Subject: NOTICE OF VIOLATION Complaint 130088 River Gorge Ranch 1A (TNR113846) Whiteside Loop Lower Tennessee River Watershed, Marion County

Compliance Inspection for General NPDES Permit for Stormwater Discharges from Construction Activities (CGP)

Project Name: River Gorge Ranch 1a (TNR113846) – complaint 130088 **Location**: off Whiteside Loop **Date**: 01/23/24 **Inspector:** Nikki Carpenter

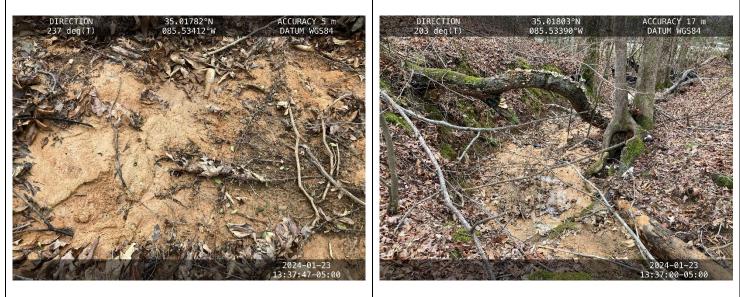
Photo 4: Evidence of sediment transport from culvert under site entrance in Photo 2 - connects directly to wet weather conveyance in sediment accumulation in Photo 3.
